Please find attached Indaver Ireland's response to Meath County Council's request for further information dated 14/03/01 for File Reference Number 01/4014.

INDAVER IRELAND

WASTE MANAGEMENT FACILITY, CARRANSTOWN

FURTHER INFORMATION

Figure 2.9.1 Noise Monitoring Locations

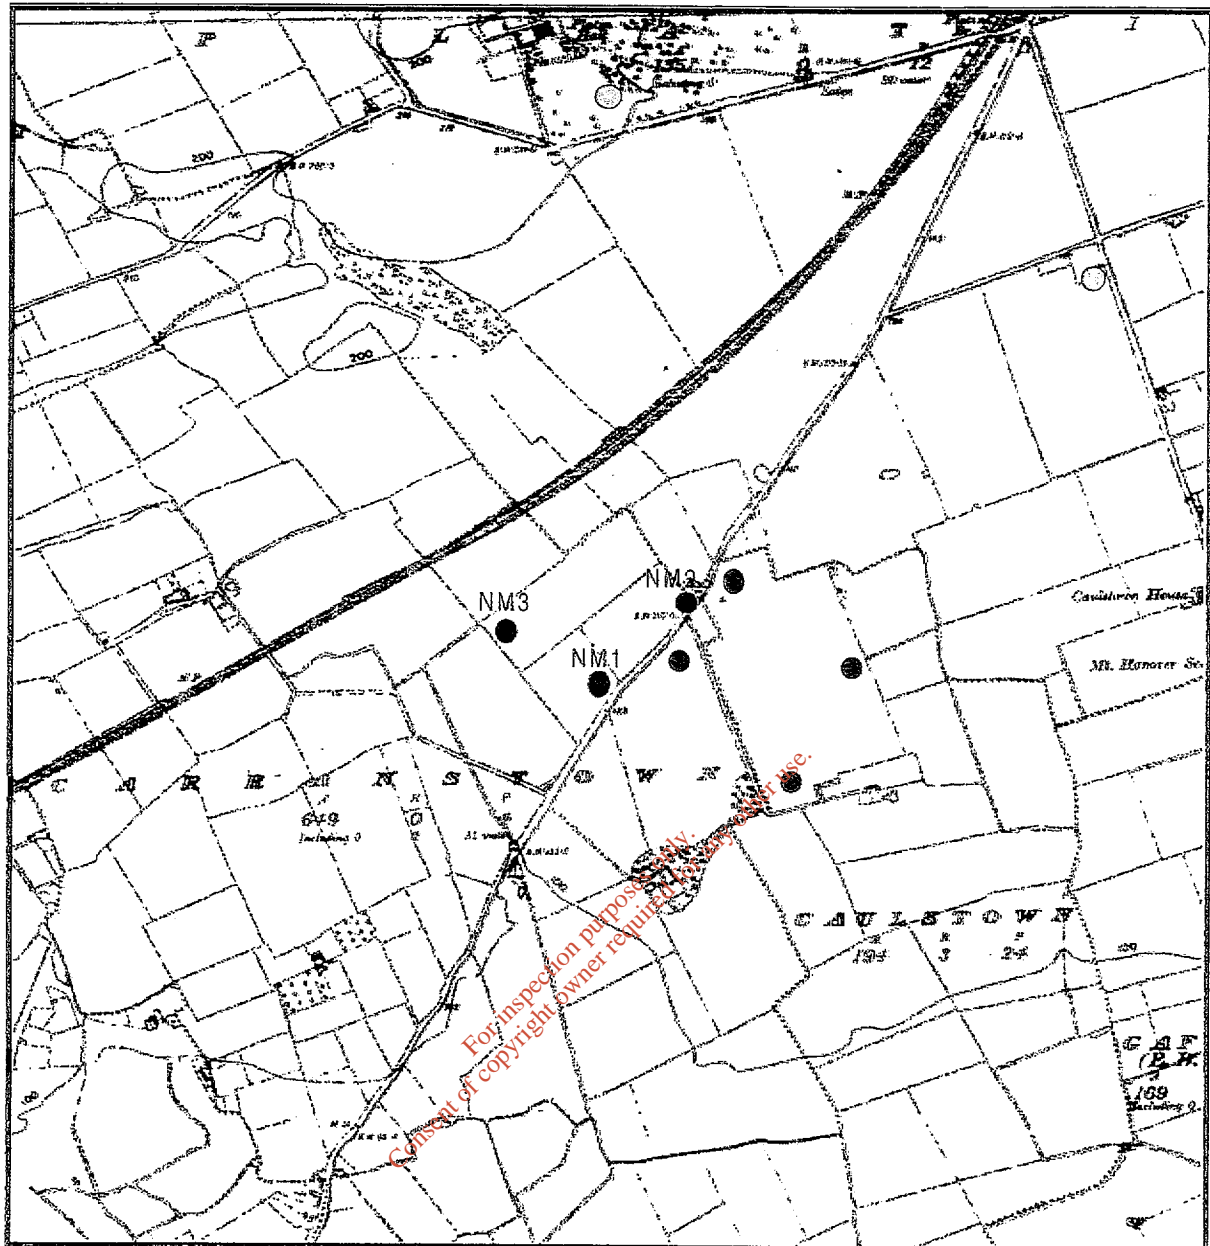
The Planning Authority considers that the EIS section on noise does not adequately assess the likely significant impacts of the proposed development on noise generated during the construction and operation phases. There are very wide variations in noise levels, particularly at night time noted over the survey period that go unexplained or interpreted. It is considered that a more detailed assessment of existing day and night time background noise levels is required. In particular the use of additional noise monitoring locations is deemed necessary to assess background noise levels and the contribution of existing noise sources in the area. The Planning Authority considers that the cumulative noise effects of the proposed development and the adjacent Platin Cement Works have not been adequately addressed in the EIS. It is also noted that in Section 5.5 of the EIS that information is not available in relation to specific noise sources. You are requested to provide an interpretation of noise survey data, highlighting any known significant noise sources together with an assessment of their contribution(s) to ambient noise levels and any difficulties in compiling information.

The EIS for the proposed Platin Power Project also contains data on background noise levels in the area. The noise levels were monitored at four points on the power plant site, which lies to the east of the proposed site. Two of the monitoring points were adjacent to the road and two were some 400m from the road. The noise levels as reported in the EIS are summarised in Tables 2.9.5 and 2.9.6 below.

FIGURE 2

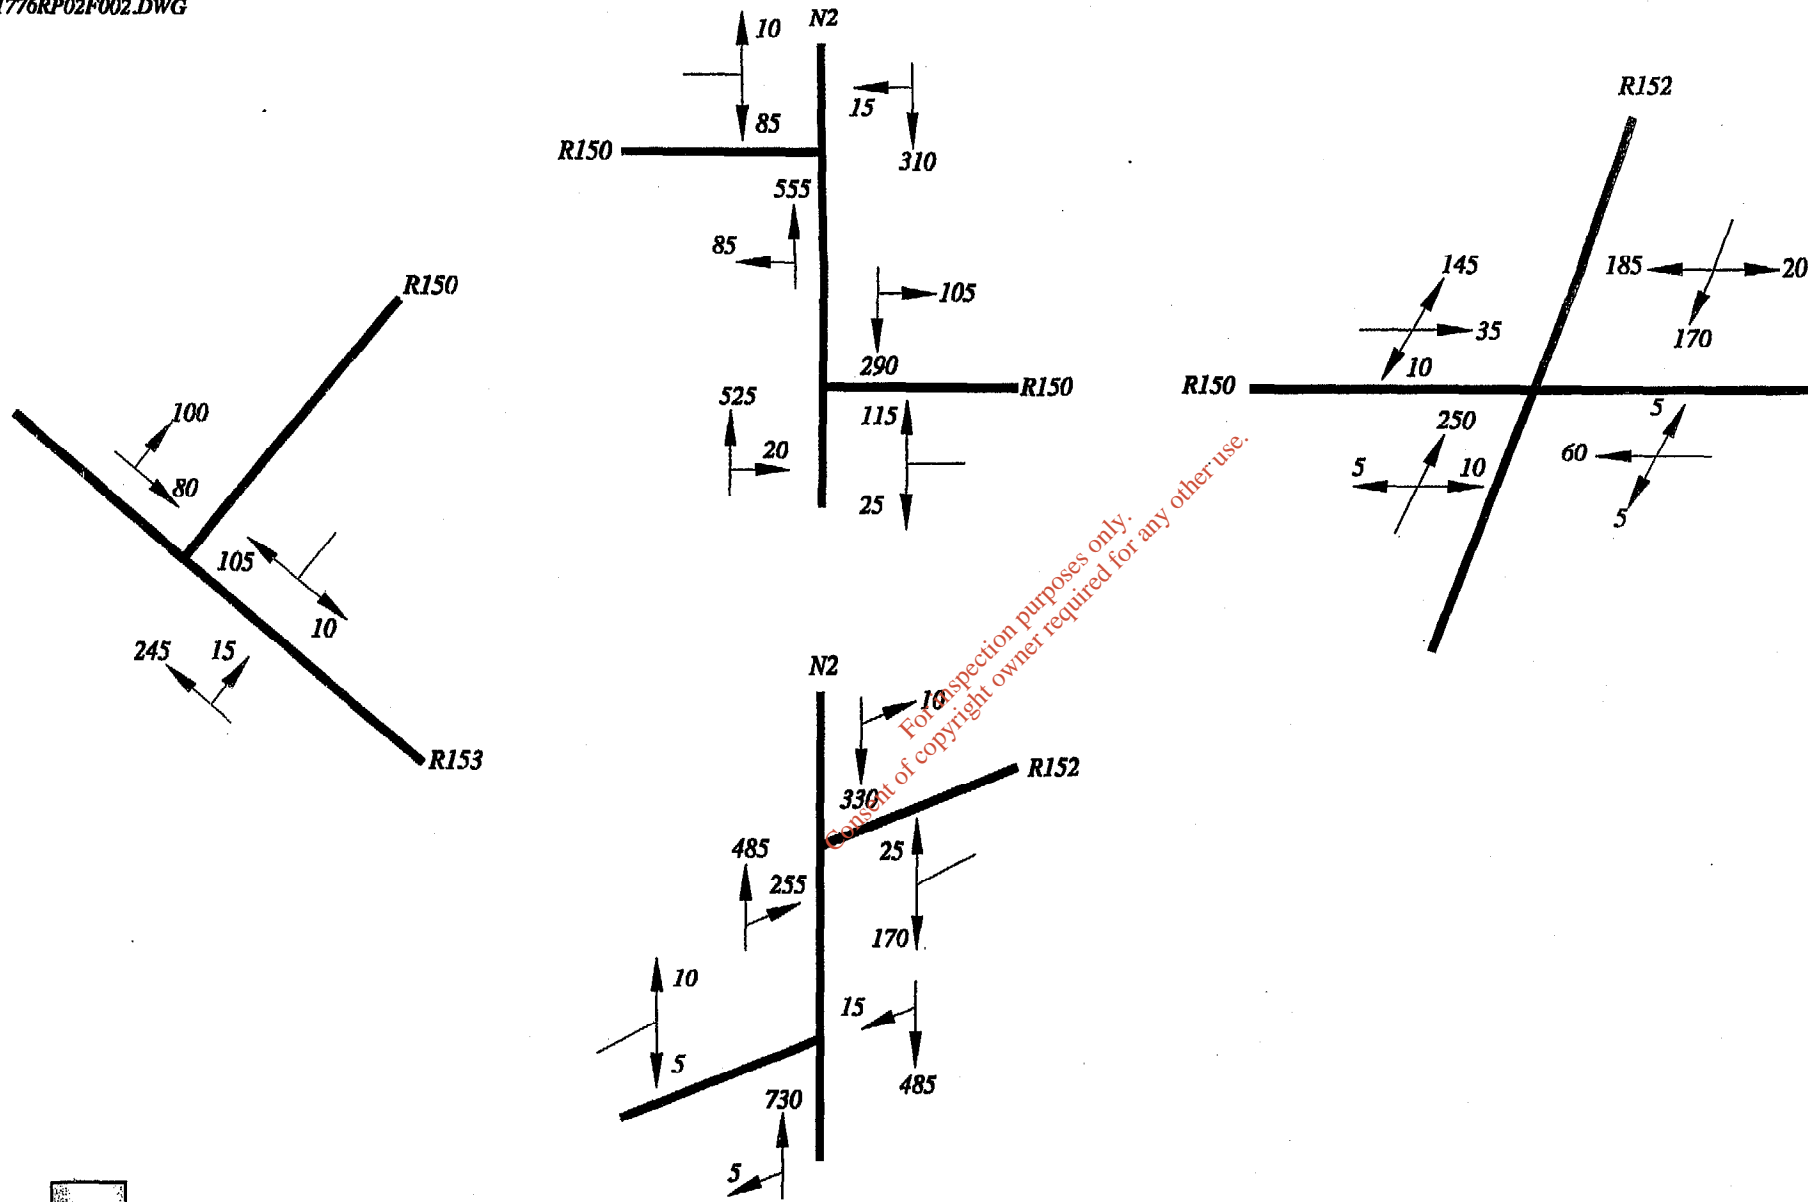
You are requested to submit details of the calculations / basis for the assessment of existing level of service of R152 and R150. The Planning Authority also considers that the traffic impacts should also be assessed in terms of Annual Average Daily Traffic counts for the network.

3.2 The overall daily peak hour occurred during the evening between 5.00 and 6.00 p.m. This coincides with the overall daily peak hour recorded during May 2000 on the R152 at the proposed development site and the R150 west of Duleek detailed in the EIS. The recorded 2001 peak hour traffic flows are shown on Figure 2.

FIGURE 3

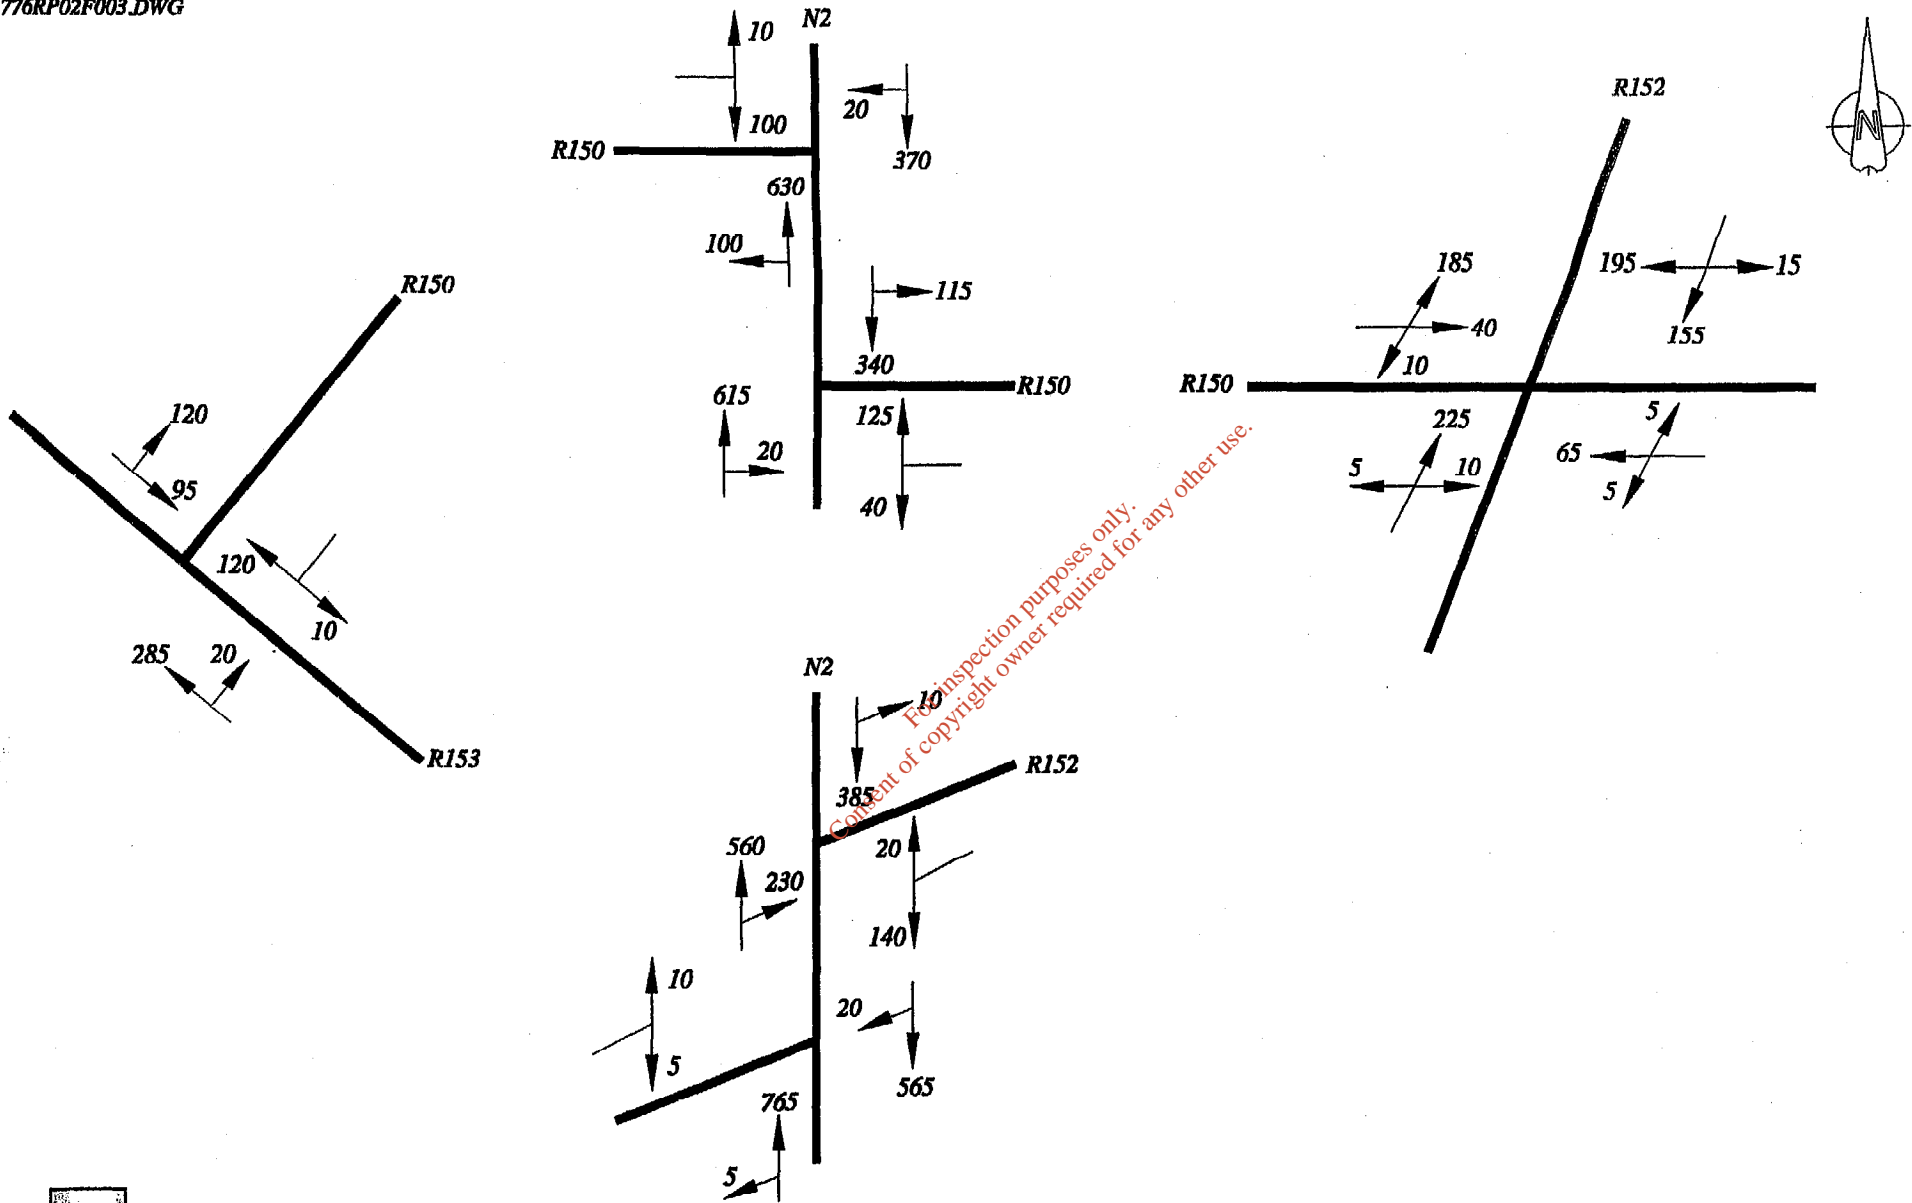
The future traffic projections are up to and including year 2004. The Planning Authority considers that the traffic projects should be expanded to assess the impacts on the road network for specific time intervals over a 20 year life based on the traffic growth percentage increases, effects of future traffic changes due to the M1 Motorway, existing and permitted development in the area, etc.

- 4.8 The predicted 2004 traffic flows without the proposed development in place were determined on the basis of the assumptions detailed above and are shown on Figure 3.

10.0 FUTURE LOCAL ROAD NETWORK JUNCTION ARRANGEMENTS

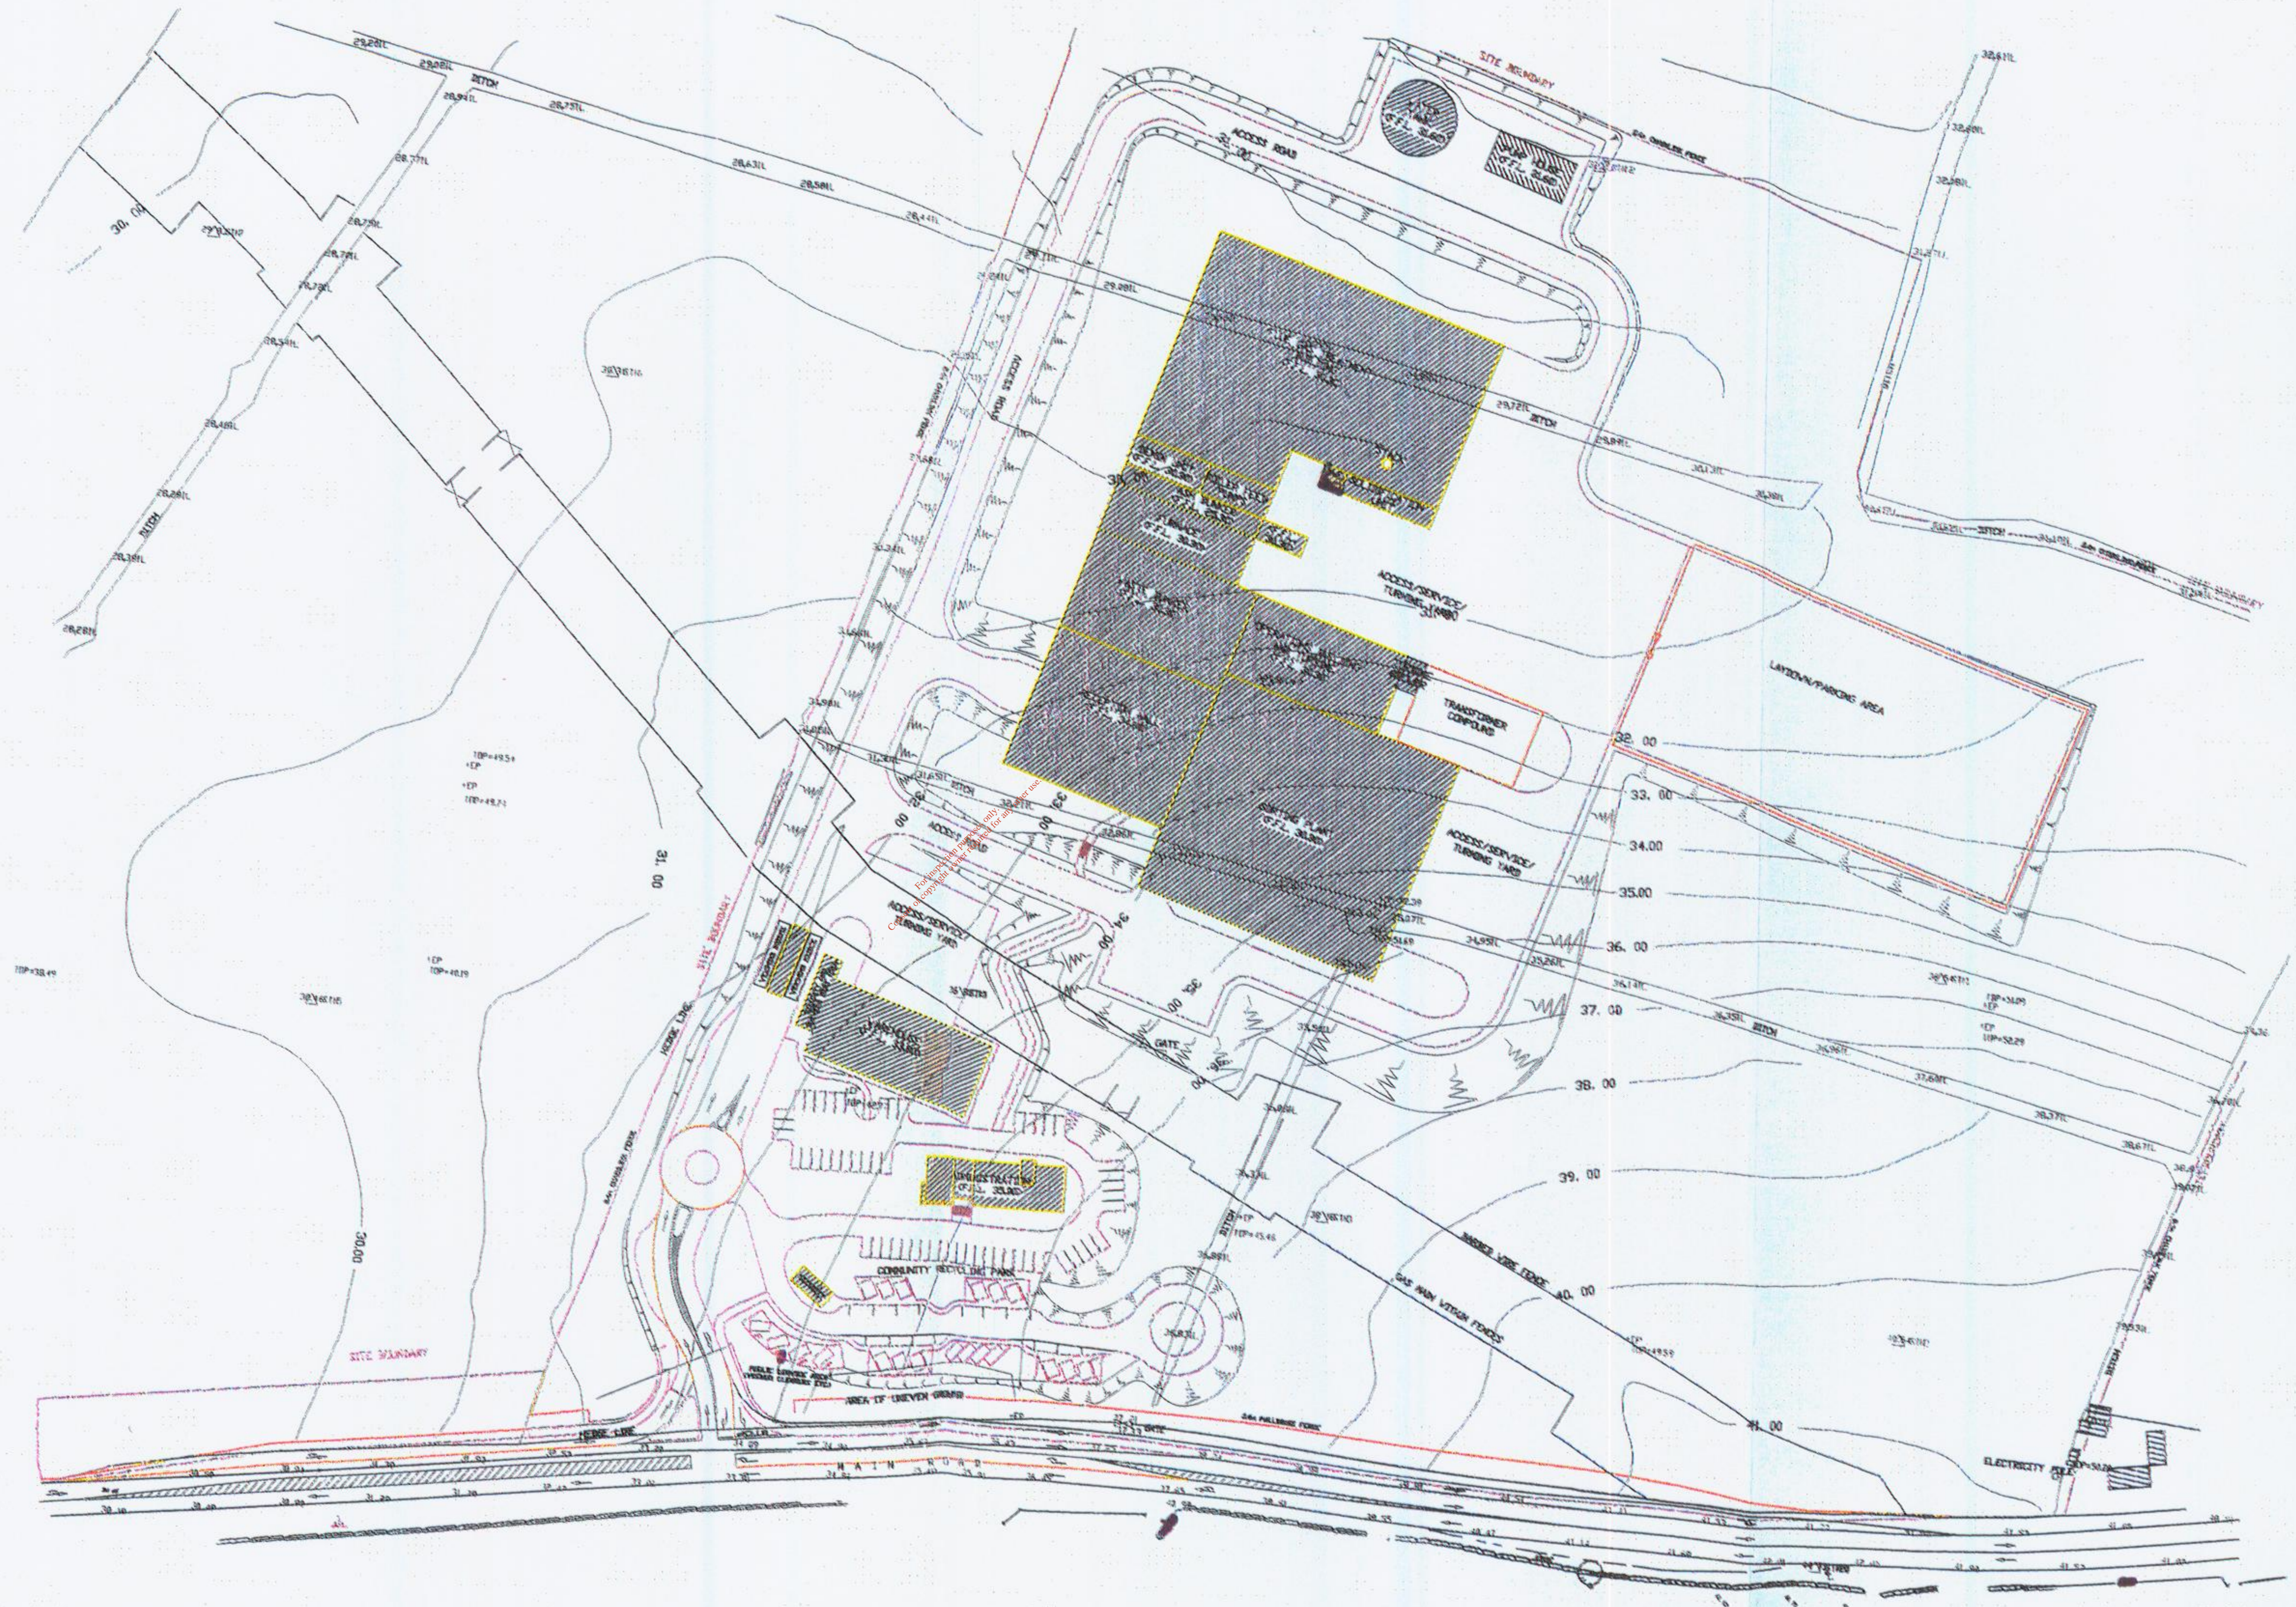
You are requested to submit your revised proposals for a junction that excludes the acceleration / climbing lane, whilst maintaining the right turn and deceleration lanes. You may wish to re-evaluate the junction capacity to take account of this revision.

5. You are requested to submit your revised proposals for a junction that excludes the acceleration/climbing lane, whilst maintaining the right turn and deceleration lanes. You may also wish to re-evaluate the junction capacity to take account of this revision.

The revised junction layout, excluding the climbing lane and including the right hand turning and deceleration lane is shown in the following drawings in Attachment F:

- 10.1 The revised proposed entrance junction on the R152 to the proposed development is shown at reduced 1:500 scale on Figure 5.
- 10.2 Meath County Council have indicated that it is proposed to provide a staggered priority controlled junction at the R152/R150 junction. Detailed drawings of the proposed layout have been provided by Meath County Council's Roads and Traffic Department.
- 10.3 It is envisaged that the existing priority controlled junction layouts at the N2/R150, N2/R152 and R150/R153 junctions will be retained.
